Addendum No. 001

Subject: George W. Childs School – Classroom Modifications
SDP Contract Nos. B-071C, B-074C of 2017/18

This Addendum, dated May 9, 2018, shall modify and become part of the Contract Documents for the work of this project. Any items not mentioned herein, or affected by, shall be performed strictly in accordance with the original documents.

DRAWING NO.
ED112

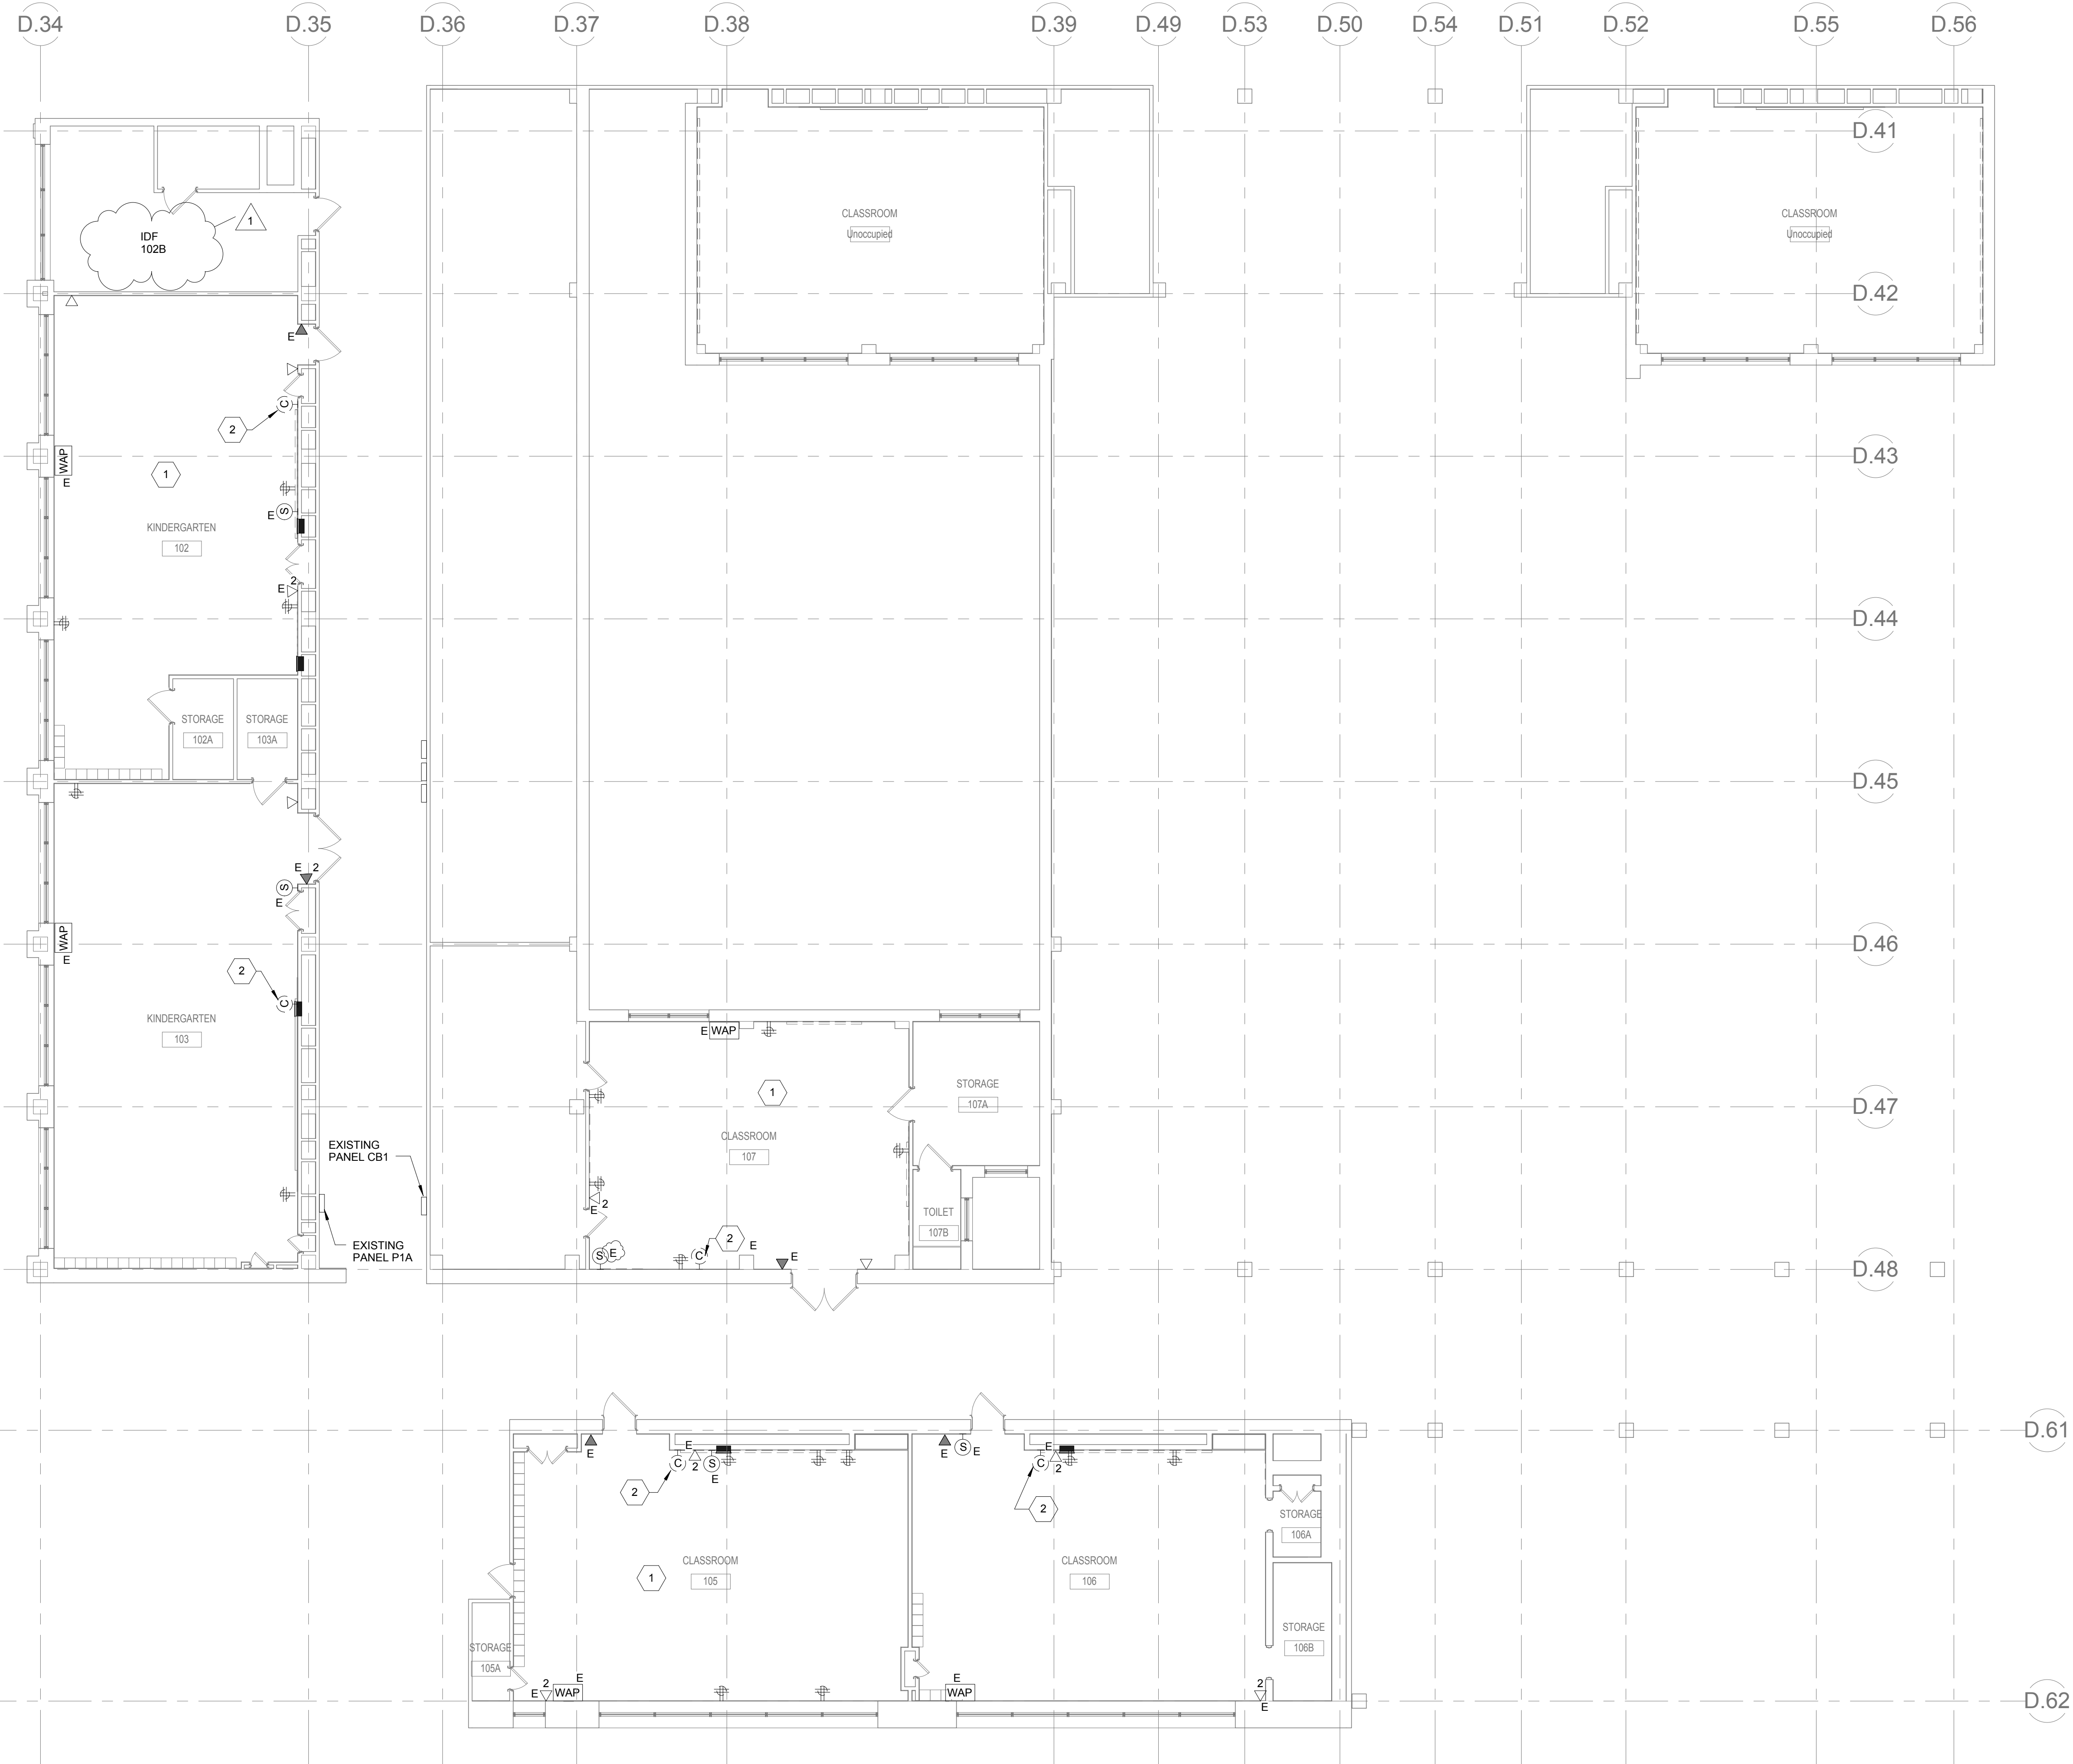
- a. Added IDF room 102B.
- b. Added key plan, graphic scale and north arrow.

DRAWING NO.
ED121

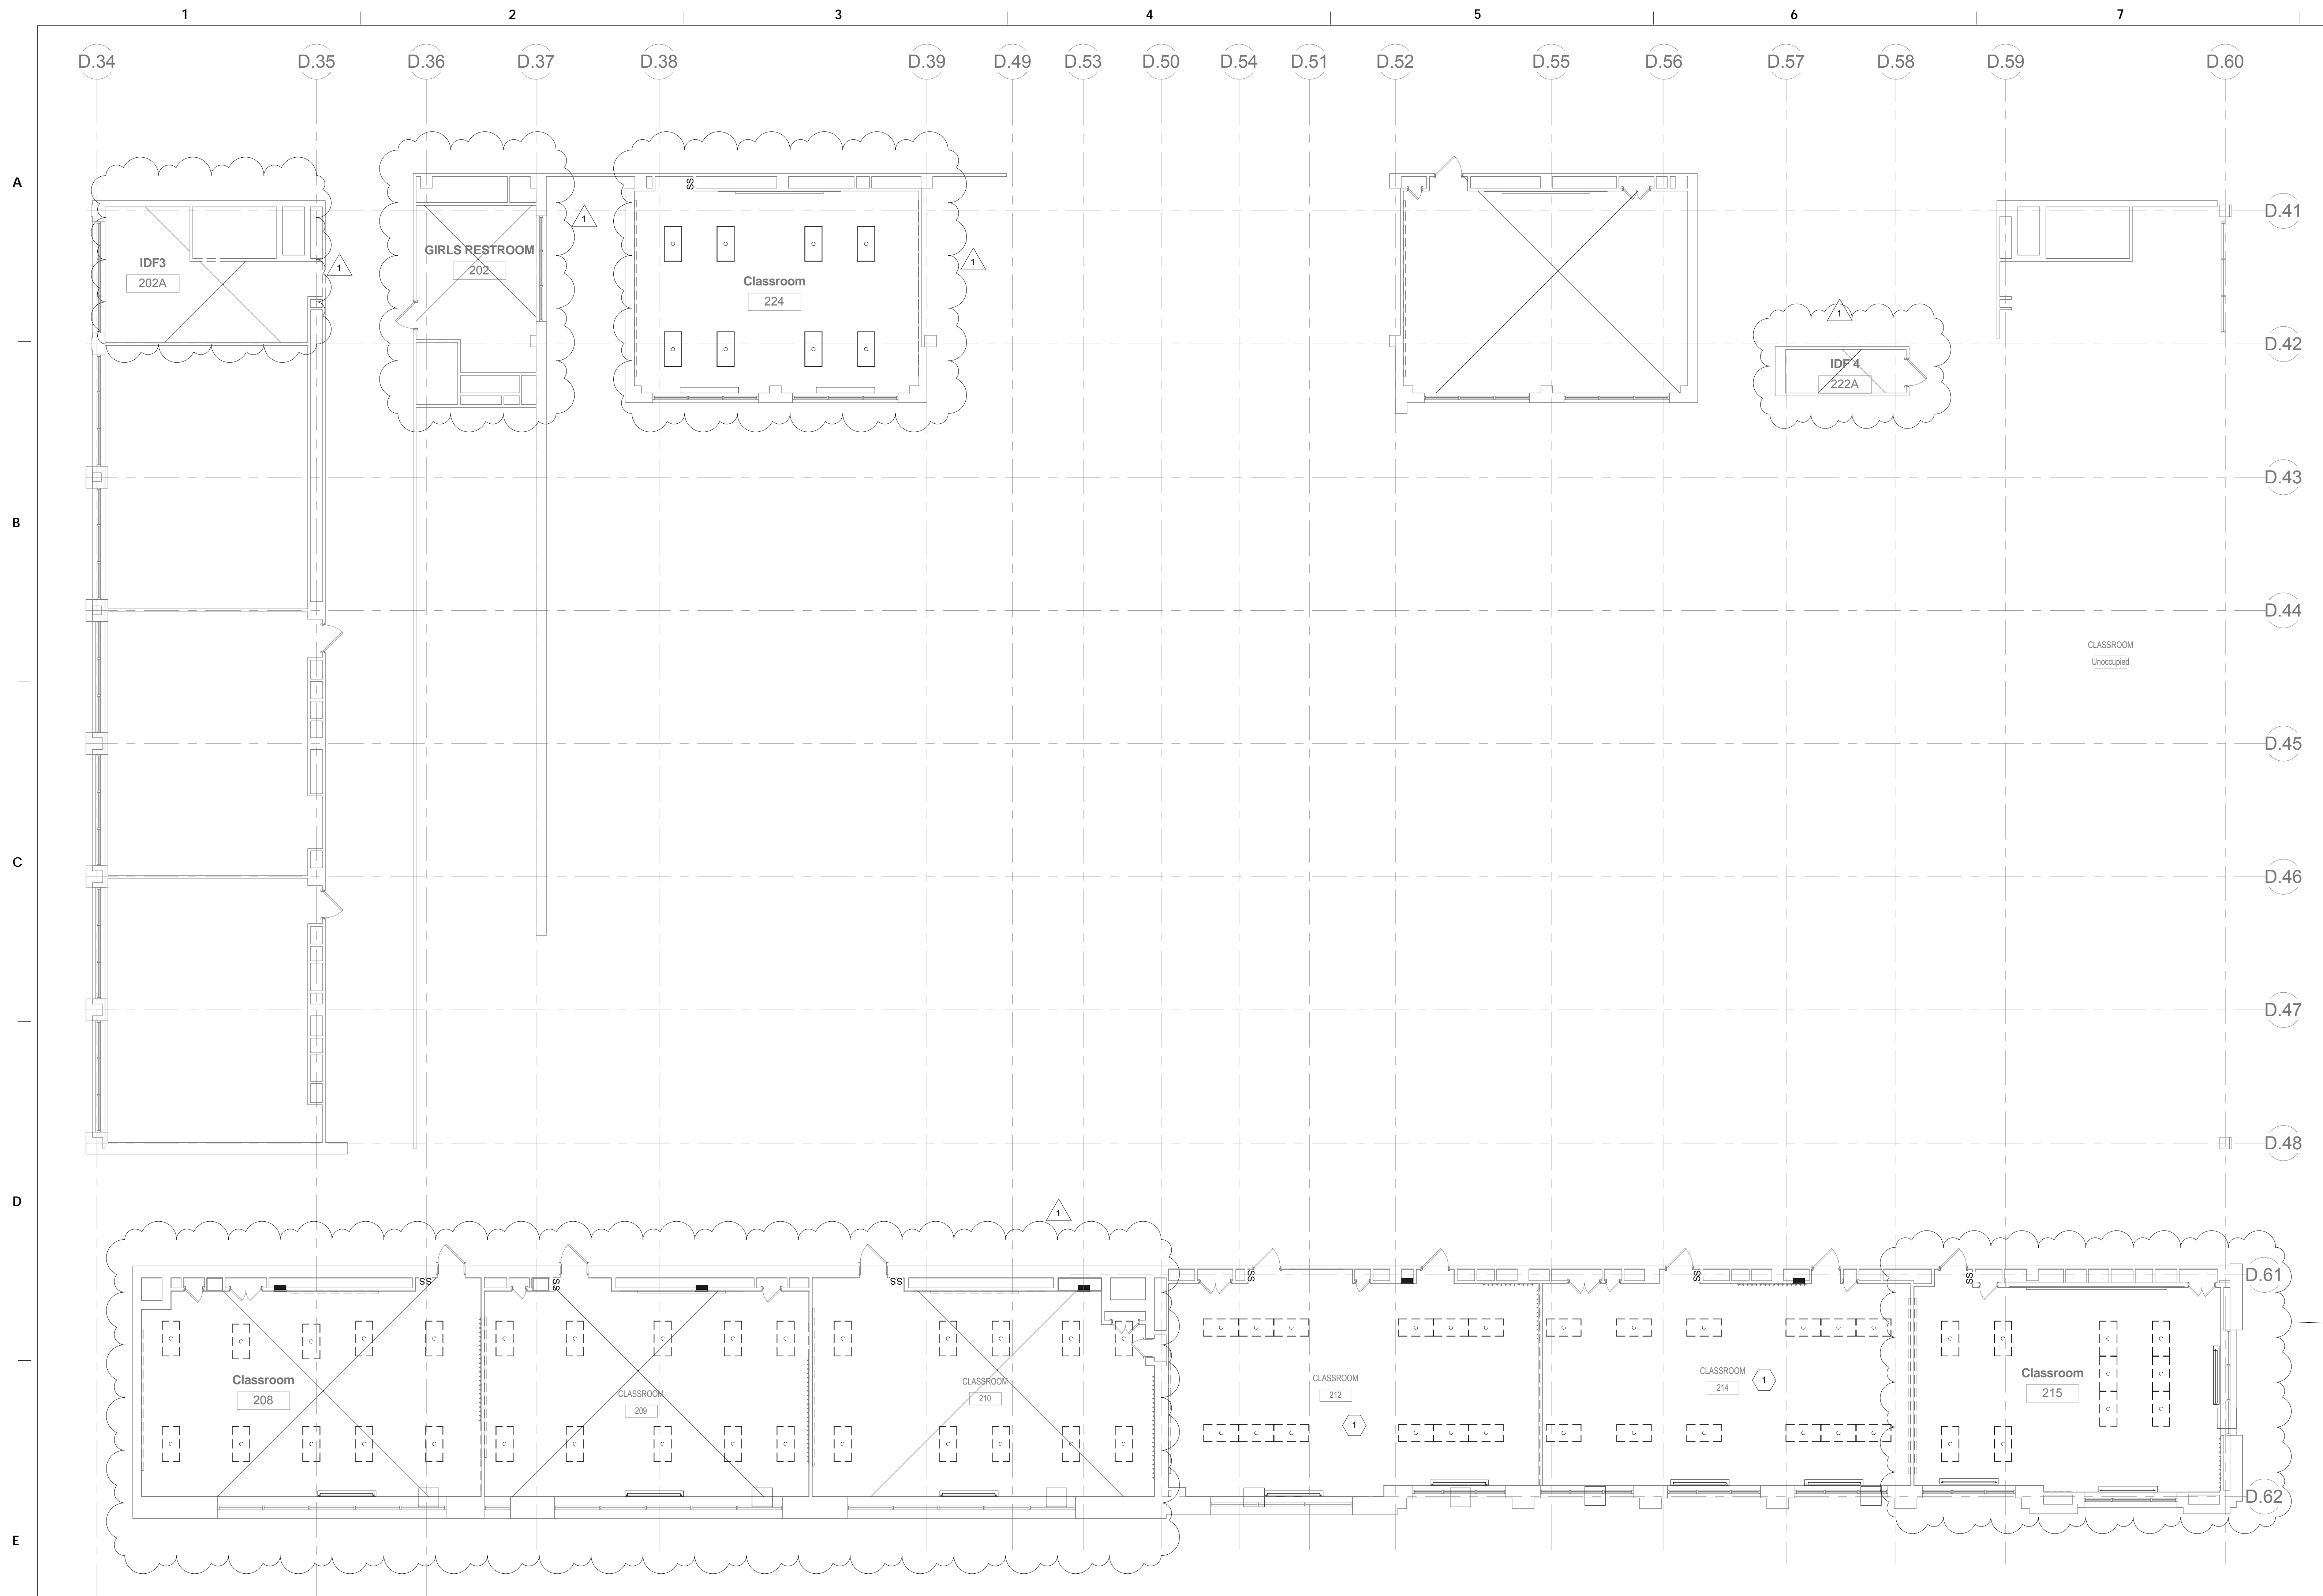
- a. Added existing lighting layout for rooms 208, 209, 210, 215 and 224.
- b. Added IDF3 room 202A, IDF4 room 222A and Girls Restroom 202.
- c. Added key note 1.
- d. Added key plan, graphic scale and north arrow.
